# Access Compliance Report

## Public Rights-of-Way

| Intersection ID: 15916                  | Main Street: BRANDON_RD | Cross Street: PEMBROKE_AV               | Location: SW           |
| ADA ID: 6B58E8C03E2C                    | Ramp Type: PerpDiag     | Initial Pass/Fail: Pass                 | Overall Compliance: No |

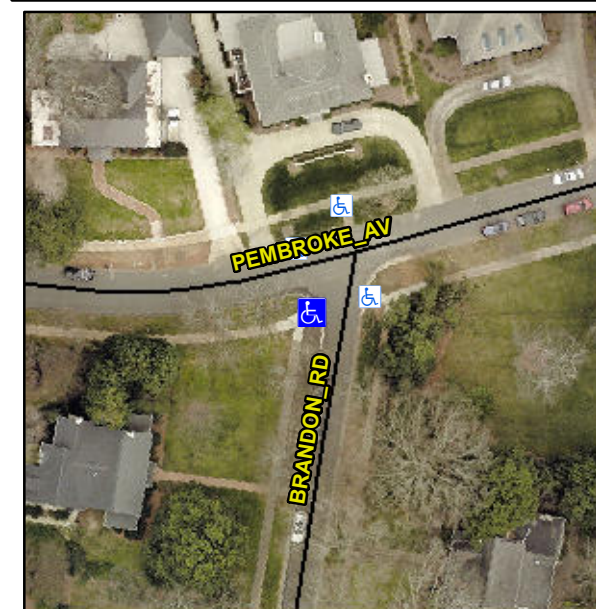
**R304.2.3, R304.5.3**

| Compliance | Description           | Data                   | Compliance | Description                 | Data |
|------------|-----------------------|------------------------|------------|-----------------------------|------|
| No         | Flare Type            | Curbed_WithWalkSurface | No         | Flare Type RT               | N/A  |
| No         | Flare Slope LT (%)    | N/A                    | N/A        | Flare Slope RT (%)          | N/A  |
| Yes        | Gutter Lip Ht (in)    | 0.0                    | No         | Gutter X Slope (%)          | 5.5  |

**Remove & Replace Curb Ramp With Two New Directional Ramps or Equivalent. Remove & Replace Gutter.**
